UPPER UWCHLAN TOWNSHIP  
PLANNING COMMISSION  
AGENDA

**May 9, 2024**

PROJECT #: 2021-231  
SHEET # 2  
18

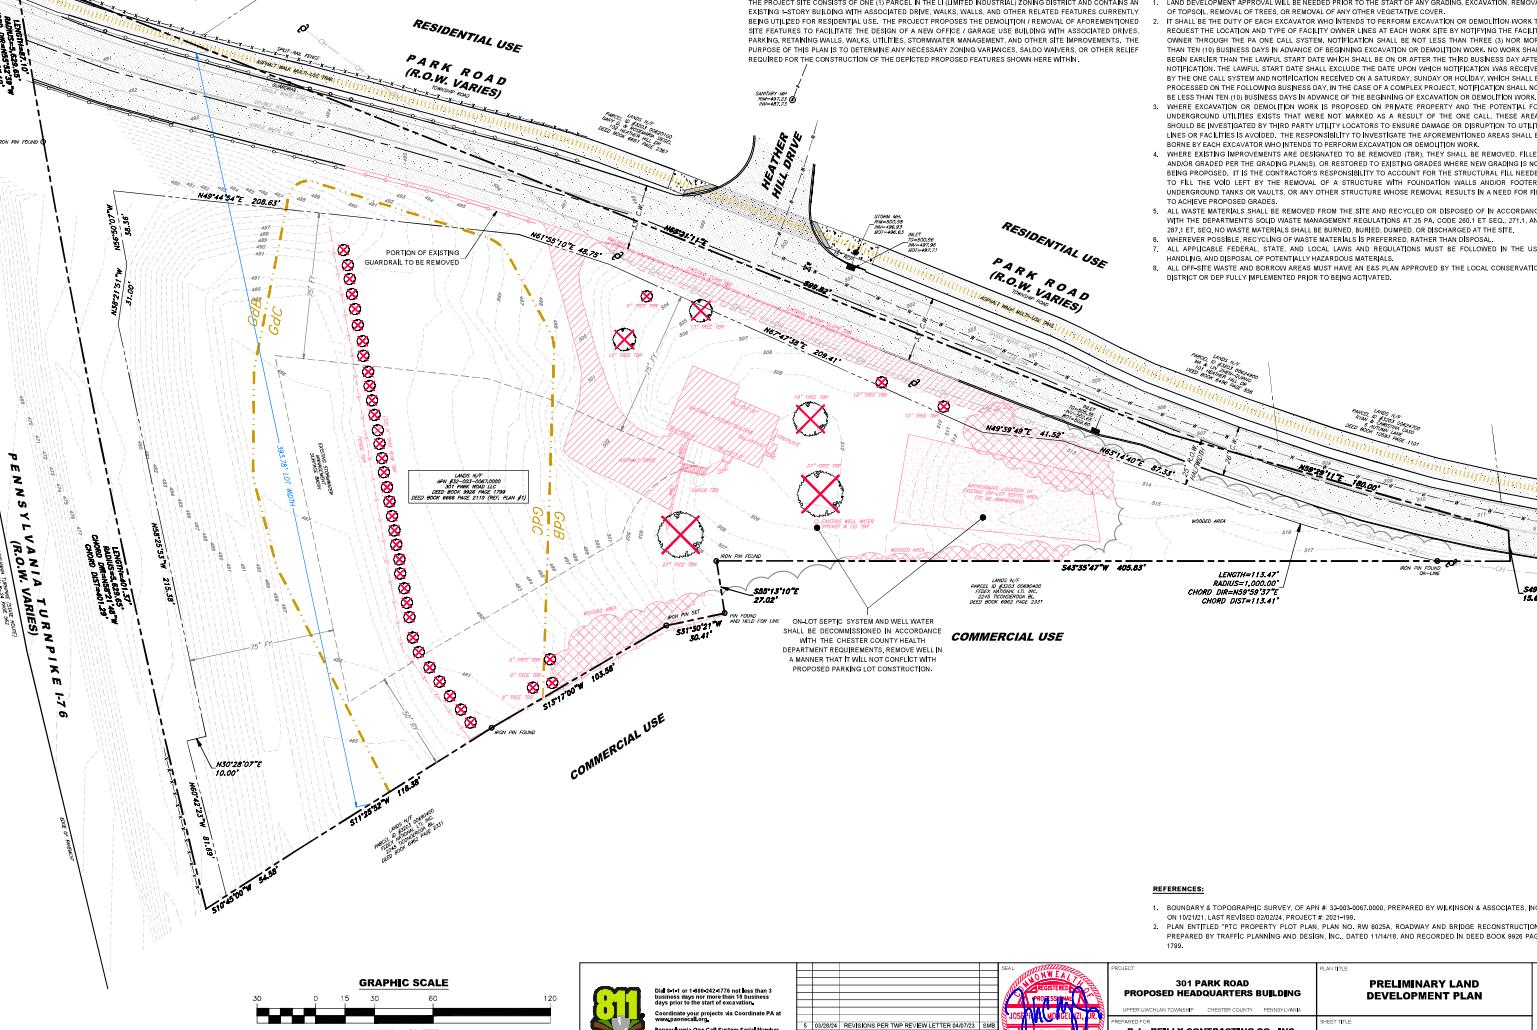
2. On Sheet 2: Clarify the "Stone drive (construction entrance)" label; no driveway outline is shown.

**Response:** *A portion of the existing guiderail is proposed to be removed. Please see the Site Analysis & Impact / Demolition Plan – Sheet 2 of 18.*
